# Product Change Notification

Product Group: DIODES / January 14th, 2015 / PCN-DD-003-2015 Rev.0

## Back-end assembly location change and 6 inches wafer qualification for DO-214AC (SMA) Schottky Products

### Package Outline Dimension

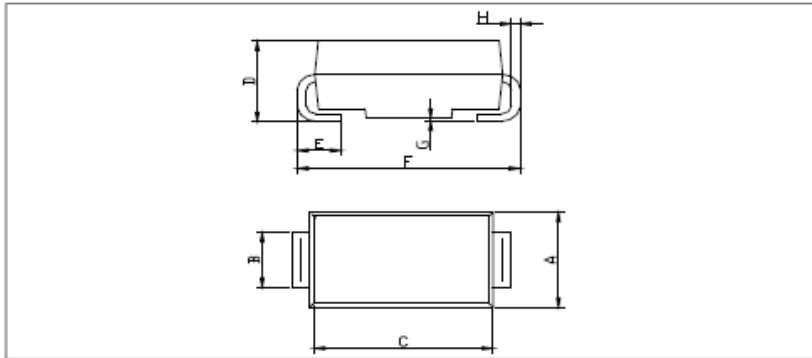
**DESCRIPTION OF CHANGE:** Vishay Diodes Division would like to announce the transfer of the subcontractor manufactured DO-214AC (SMA) Schottky products to Vishay in house factory in Tianjin China.  
 Package Outline Dimension will be slightly different but still meeting JEDEC specification tolerances.  
 Details of changes of device marking, label and packaging are shown from page 3 to 5.  
 Together with the back-end assembly location and structure changes the Silicon Wafer diameter used as raw material will change from 5 inches (125 mm) to 6 inches (150 mm).  
 Taking the chance of the subjected changes to be implemented in this PCN, Vishay Diodes will also launch the halogen free version materials with the -M3 code and also the its AEC Q-101 qualified corresponding material with HM3 code.

SMA	Unit:mm	A	B	C	D	E	F
New	Spec	2.54~2.79	1.24~1.65	3.99~4.50	1.98~2.29	0.76~1.52	4.93~5.28
	Typical value	2.63	1.57	4.28	2.09	1.06	5.12
Current	Spec	2.55~2.65	1.46~1.54	4.15~4.25	1.97~2.03	0.87~1.13	4.98~5.18
	Typical value	2.6	1.5	4.2	2	1	5.08
